1. Engineering Department Staff Report Memo,  
May 6, 2024

**Subject:** Preliminary Plat Engineering Staff Report | Audrey Estates | P-11-10-22-01

**To:** Edie Berghoff, Senior Planner  
**From:** Michael Bateman, PE | Transportation Engineer  
**Subject:** Audrey Estates Preliminary Plat Recommended Conditions of Approval  
**Date:** May 06, 2024  
**Approved By:** Josh Ranes, PE, City Engineer

6. Figure TR-3 2036 New Roadway Segments Map,  
Land Use Comprehensive Plan Transportation Element

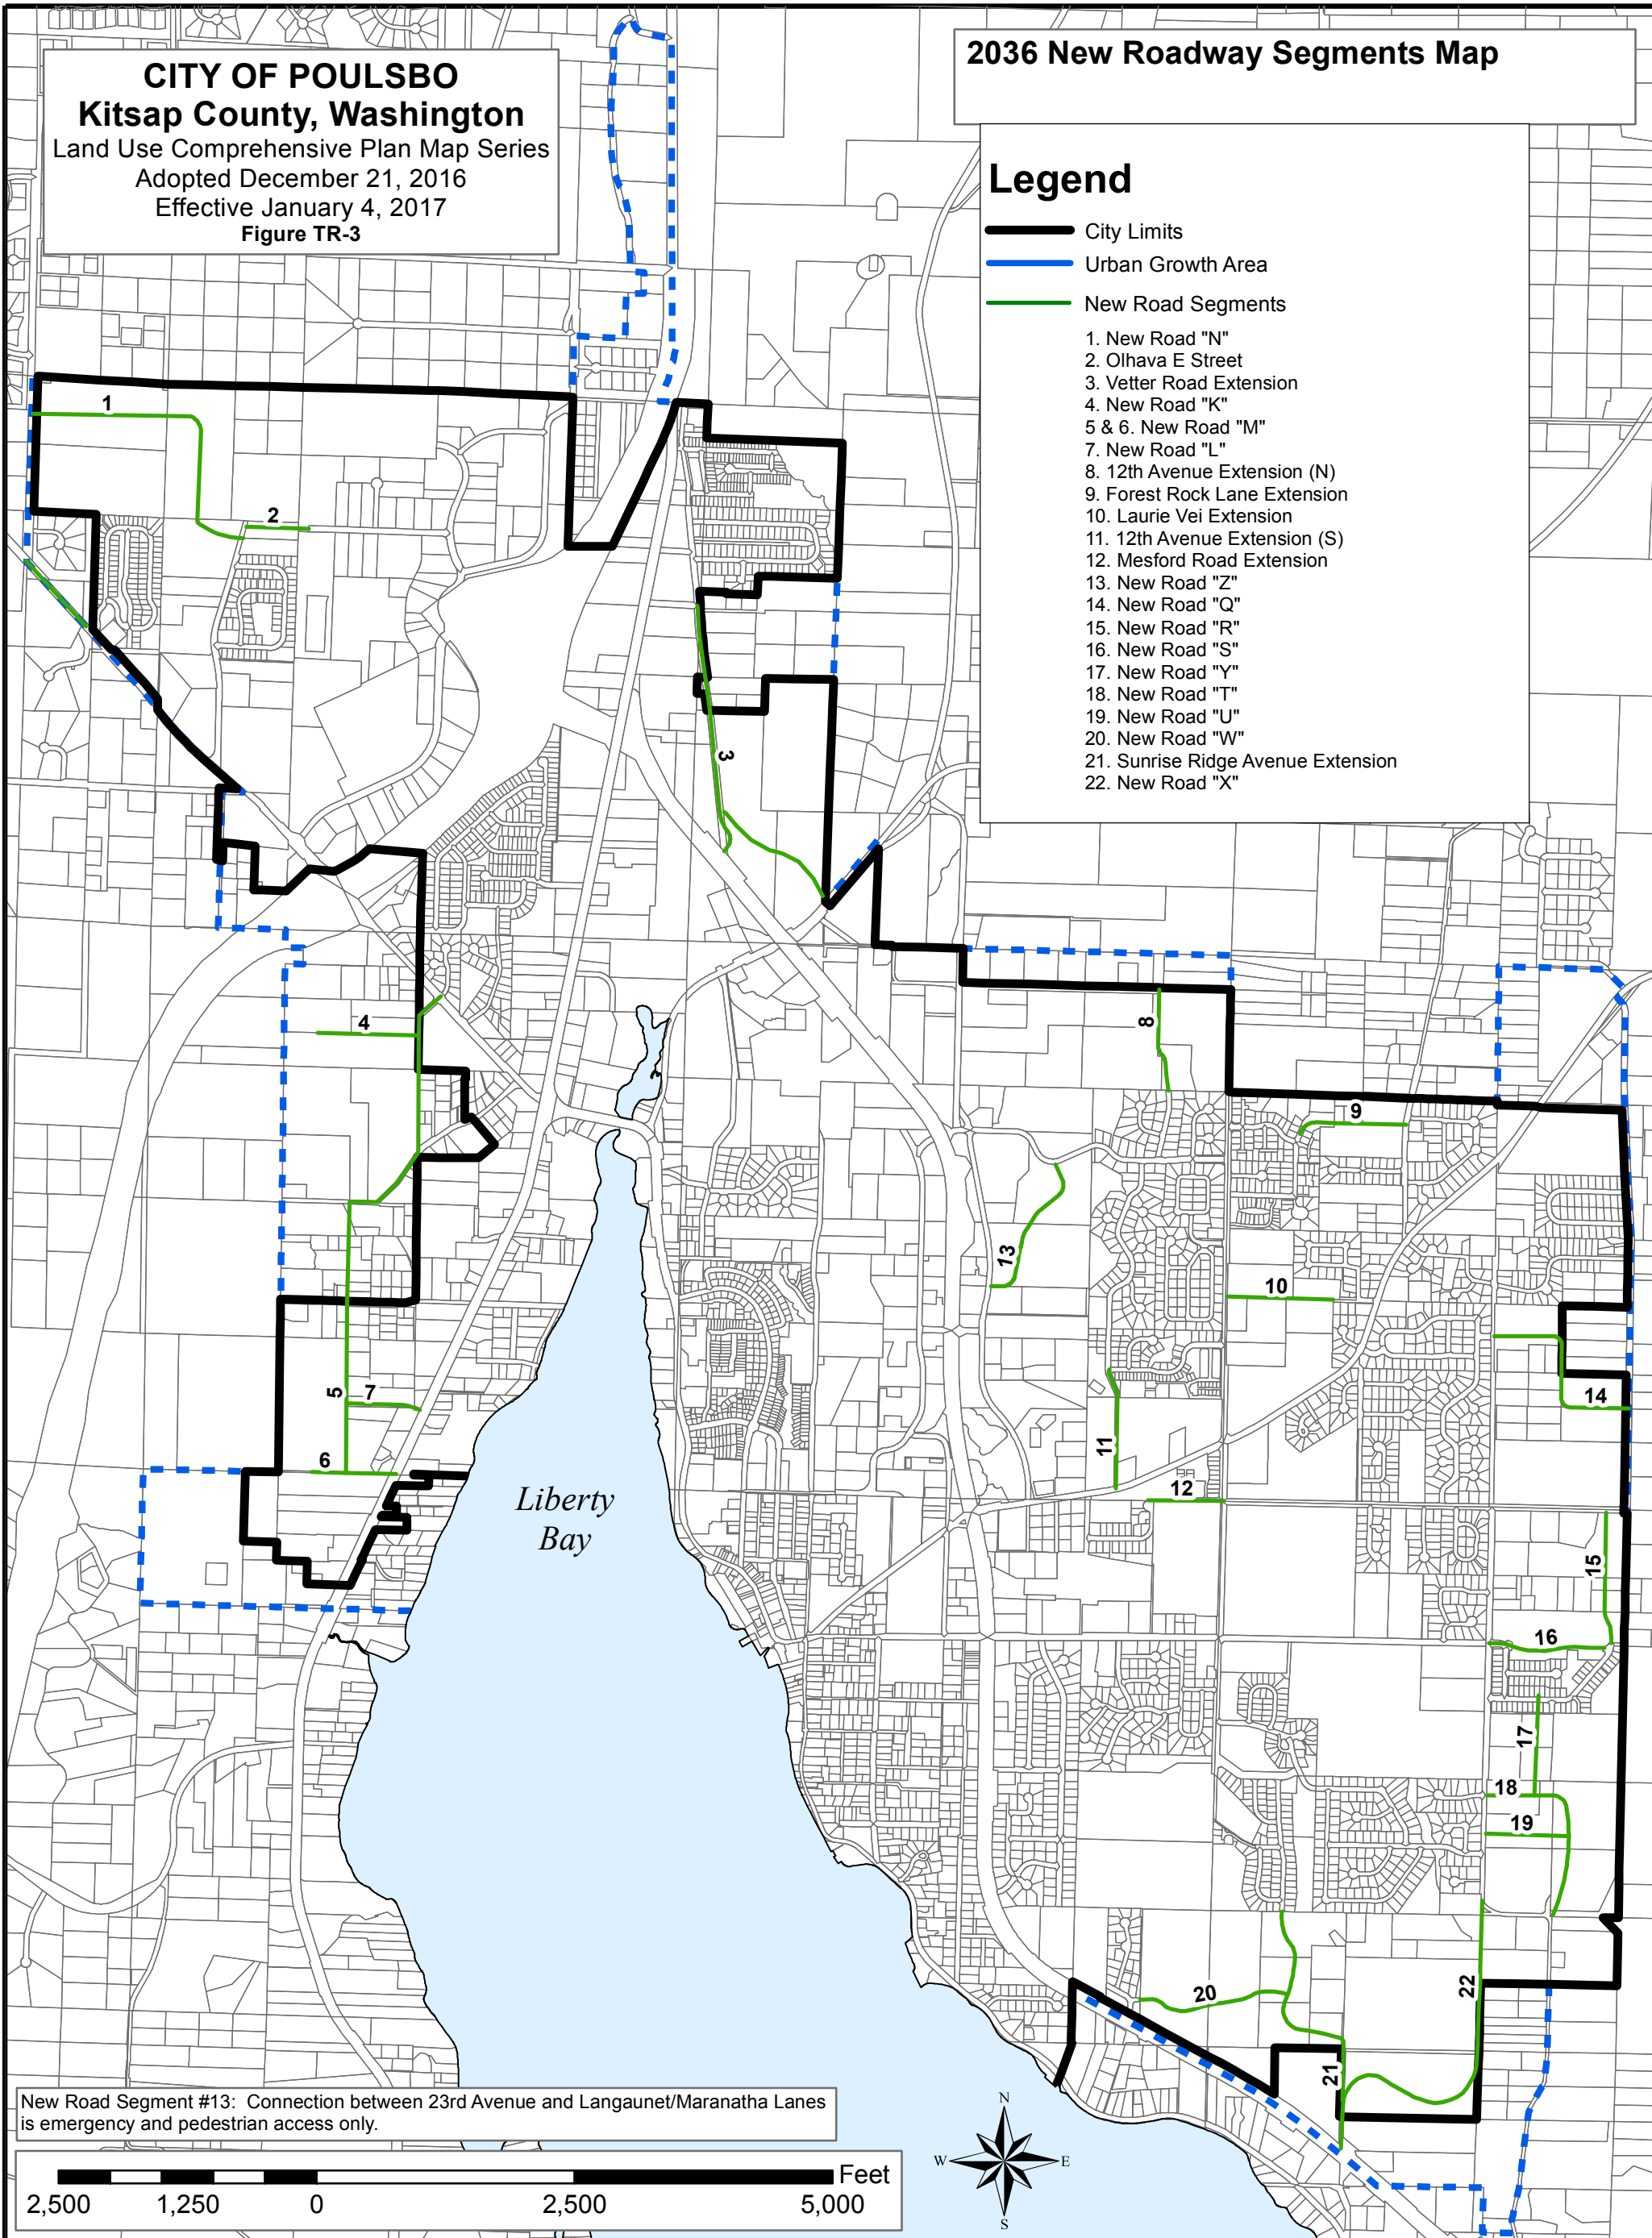
The City's Comprehensive Transportation Plan Update section 6.1.1 and City Comprehensive Plan Chapter 4 New Roadway Segments Map Figure TR-3 (Exhibit F3) show required collector/sub collector level roadway connections. Development projects are required to meet the intent of these new roadway connection requirements within the project and provide and/or provide accommodation for these future roadway connections.

This project's primary roadway network within the site as proposed complies with City standards for roadway classification, grade and alignment. Reference Exhibit A3 Project narrative pg. 10, 28 & 29 for further discussion. New Roadway Segment 21 is identified on Poulsbo Comprehensive Plan map TR-3 (Exhibit F3) as a required future roadway segment. This project will complete a portion of new roadway 21 (Sunrise Ridge NE) within the property boundary connecting to existing City roadway Johnson Parkway NE and provide for the future extension of new roadway 21 through currently undeveloped adjacent parcels 242601-3-005-2006 and 242601-3-018-2001 for future connection to the existing Sunrise Ridge Road NE in the plat of Crystal View. The future roadway stub (Road D) to parcel 242601-3-033-2002 to the North and Sunrise Ridge Road NE extension to the West meets the requirement of PMC 17.80.060(B) for future roadway connections to adjacent properties. Future roadway stub (Road D) to the North provides for a future second standard point of access/egress per the requirements of PMC 17.80.060(B).

Staff have analyzed the requirements of PMC 17,80.050, 17.80.060, City Construction Standards, City Transportation Plan, City Comprehensive Plan, International Fire Code and City Water Comprehensive Plan requirements and determined that as-proposed in the project documentation the proposed roadway network connections and future roadway network stubs provided will adequately satisfy these requirements.
